HISTORIC PRESERVATION COMMISSION

SUBJECT: Historic Area Work Permit #460634, side addition

Address: 3720 Bradley Lane, Chevy Chase

HISTORIC PRESERVATION COMMISSION STAFF REPORT

1 EAST ELEVATION
A3 1/4" = 1'-0"

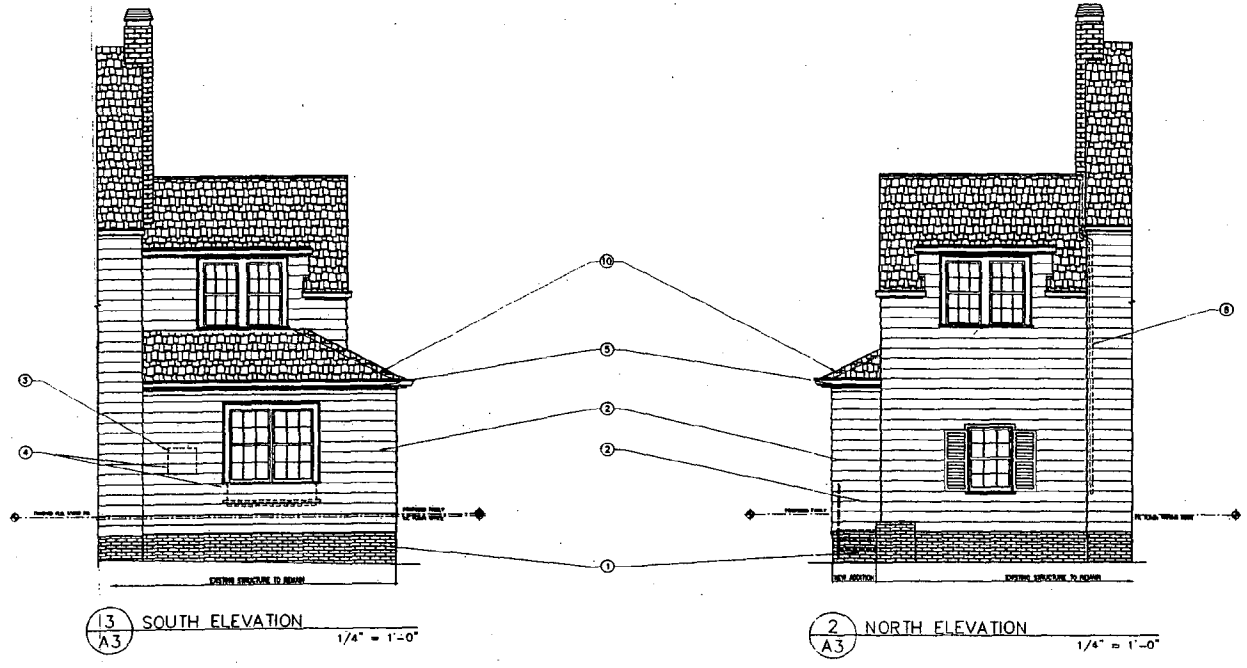
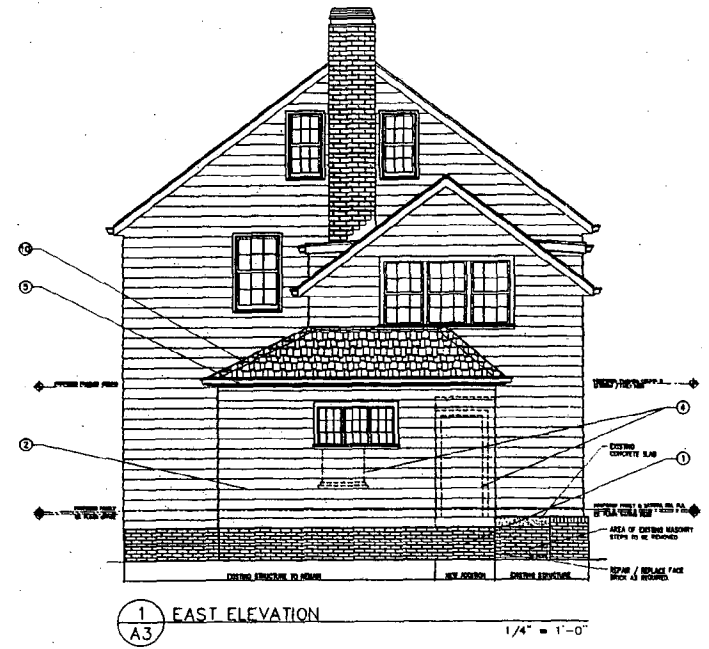
- 1. The applicant will work with the Chevy Chase Village arborist to identify if a tree protection plan is needed for the proposed work. If required, the plan will be implemented prior to any work beginning on the property.*
- 2. Aluminum clad windows are not approved. All windows must be constructed of painted wood. (Details to be shown on permit set of drawings).*

- The applicant will work with the Chevy Chase Village arborist to identify if a tree protection plan is needed for the proposed work. If required, the plan will be implemented prior to any work beginning on the property.
- Aluminum clad windows are **not** approved. All windows must be constructed of painted wood. (Details to be shown on permit set of drawings).
